ARLINGTON AVENUE BRIDGES REPLACEMENT

Design Review Committee Meeting #8 | December 13, 2022

2 ARLINGTON STREET BRIDGE - SOUTH ABUTMENT ELEVATION
NO SCALE

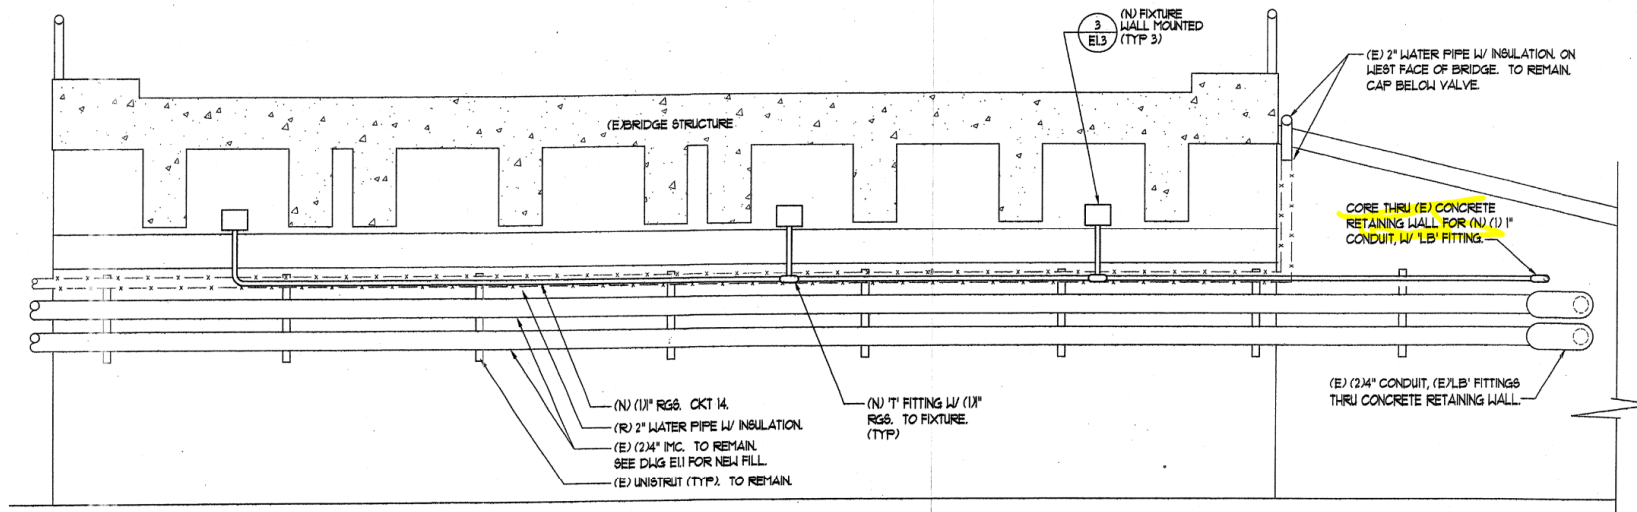
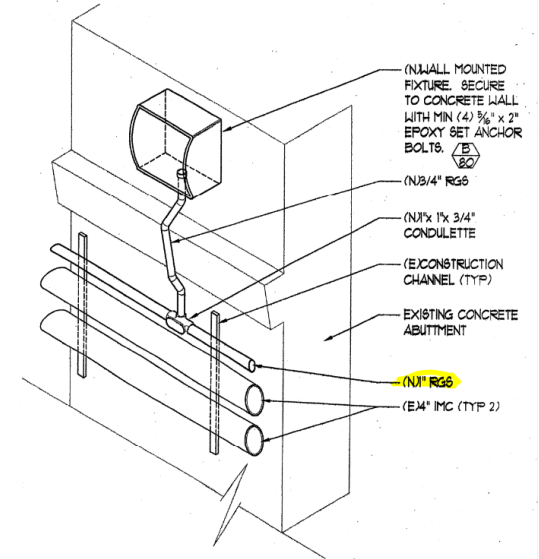
- 1 - 1" Electrical Conduit:
Under bridge lighting?
